龙芯派-2K1000-Q

Change history

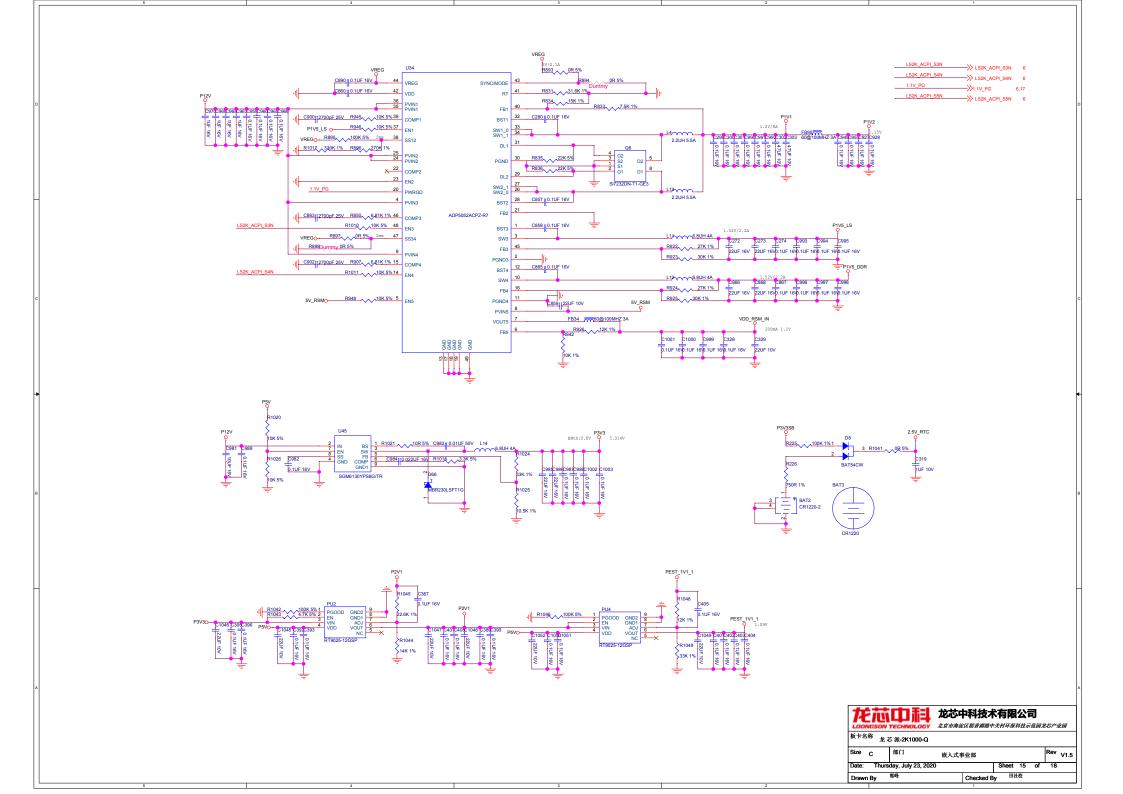
Change the ALC269's outout to HPOUT Change the MIC's circuit Dummy the MIC_JD's resistor Change the HPOUT_JD's resistor to 39.2K
